P 517427

## ON-SITE SEWAGE DISPOSAL SYSTEM HOWARD COUNTY HEALTH DEPARTMENT BUREAU OF ENVIRONMENTAL HEALTH

ADDRESS: 6195 Lawyers Hill PROPERTY OWNER: Yuka Manabe

TRENCHES:	Trench to be 3 feet wide. Inlet 4 feet below original grade. Bottom maximum depth $9\frac{1}{2}$ feet below original grade. Effective area begins at $8\frac{1}{2}$ feet below original grade. $5\frac{1}{2}$ feet of stone below distribution pipe.
LOCATION:	Old Tank & Dry well to be properly abandoned. New Tank to be located 10' from proposed addition.
PURPOSE:	In support of future building additions.

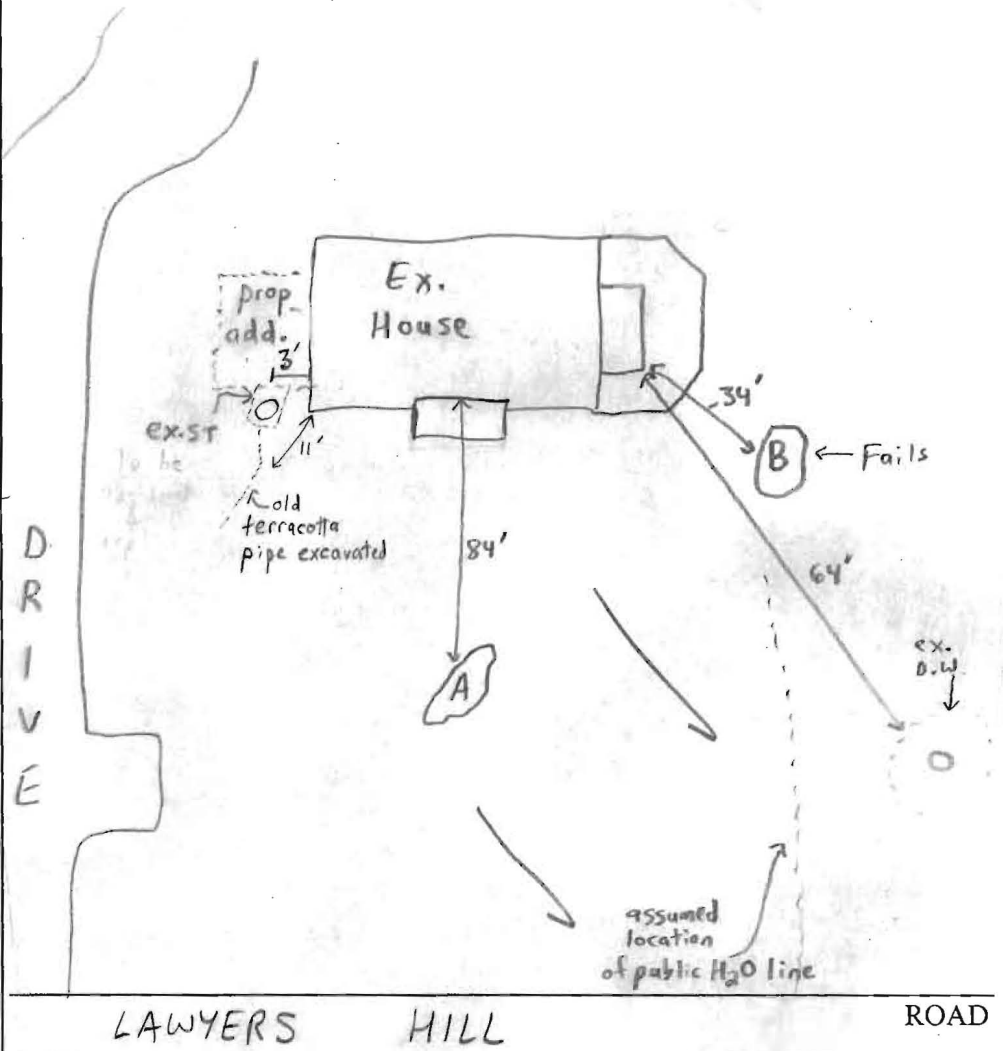
PRE-CONSTRUCTION 9/3/02 - EXCAVATED PERC HOLES IN LOCATION (A) & (B) SEE PERC NOTES, INSTALL SYSTEM IN FRONT YARD PER SPECS, OLD S.T. & DRYWELL TO BE PROPERLY ABANDONED, OPEN TRENCH INSP. REQUIRED PRIOR TO PLACING STONE IN TRENCHES - (SRK/JS)

10/7/03 - NO WORK DONE AS OF THIS DATE  
INDEX FILE - (SRK)
